INTERNATIONAL CODE COUNCIL

2018 – 2019 CODE
DEVELOPMENT CYCLE
Group B (2019)

2019 REPORT OF THE COMMITTEE ACTION
HEARINGS ON THE 2018 EDITIONS OF THE
GROUP B INTERNATIONAL CODES

HELD IN ALBUQUERQUE, NM
APRIL 28 – MAY 8, 2019

**FIGURE C405.2.3.2
SIDELIT DAYLIGHT ZONE**

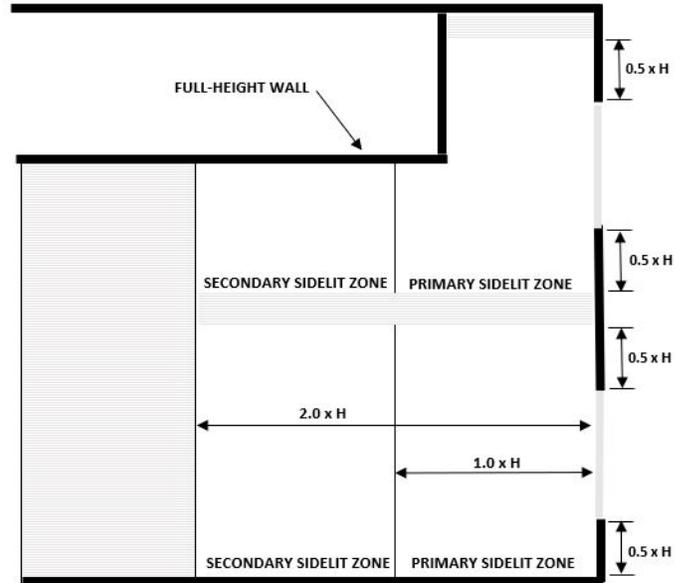
Committee Modification:

C405.2.3.2 Sidelit zone. The sidelit daylight zone is the floor area adjacent to vertical fenestration that complies with all of the following:

1. Where the fenestration is located in a wall, the primary sidelit daylight zone shall extend laterally to the nearest full-height wall, or up to 1.0 times the height from the floor to the top of the fenestration, and longitudinally from the edge of the fenestration to the nearest full-height wall, or up to ~~4/2~~ 0.5 times the height from the floor to the top of the fenestration, whichever is less, as indicated in Figure C405.2.3.2.

2. The secondary sidelit daylight zone is directly adjacent to the primary sidelit daylight zone and shall extend laterally to 2.0 times the height from the floor to the top of the fenestration or to the nearest full height wall, whichever is less, and longitudinally from the edge of the fenestration to the nearest full-height wall, or up to 1/2 0.5 times the height from the floor to the top of the fenestration, whichever is less, as indicated in Figure C405.2.3.2.

Figure R704.2.1 Typical Single Span Vinyl Soffit Panel Support

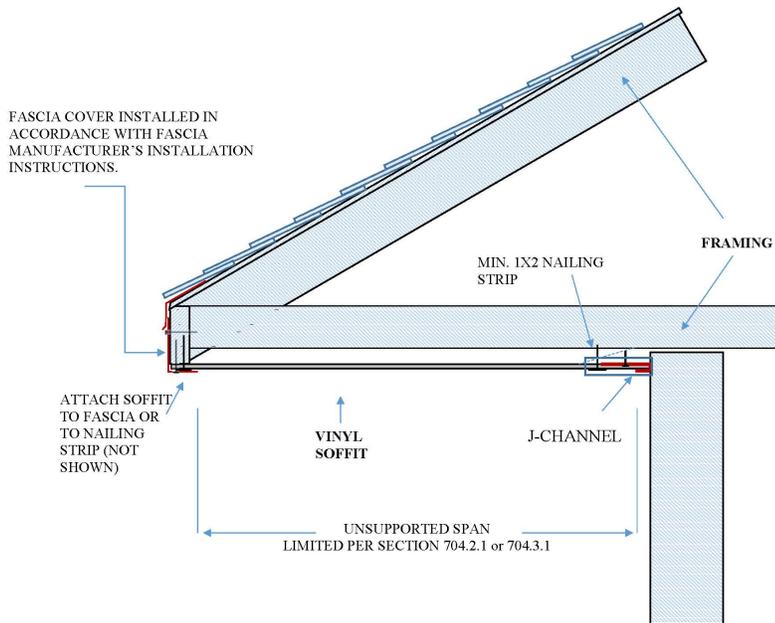
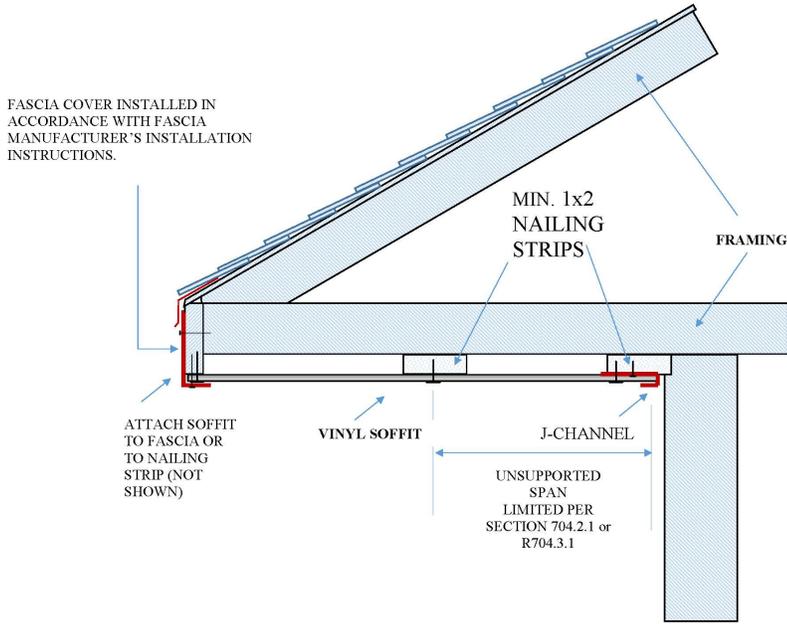
R704.2.1 Vinyl soffit panels. Vinyl soffit panels shall be installed using fasteners specified by the manufacturer and shall be fastened at both ends to a supporting component such as a nailing strip, fascia or subfascia component in accordance with Figure R704.2.1. Where the unsupported span of soffit panels is greater than 16 inches, intermediate nailing strips shall be provided in accordance with Figure R704.2.2. Vinyl soffit panels shall be installed in accordance with the manufacturer's installation instructions. Fascia covers shall be installed in accordance with the manufacturer's installation instructions.

Delete Proposed Figure R704.2.1 and Replace with the two following figures, R704.2.1 and R704.2.2:

Committee Reason: The modification to Section 704.2 and 704.3 will allow for soffits of other materials. The modification to replace Figure R704.2.1 with two figures provides clarification for single and double span soffits. The committee felt that the proposal appropriately addresses the requirements for soffits in high wind areas. (Vote: 11-0)
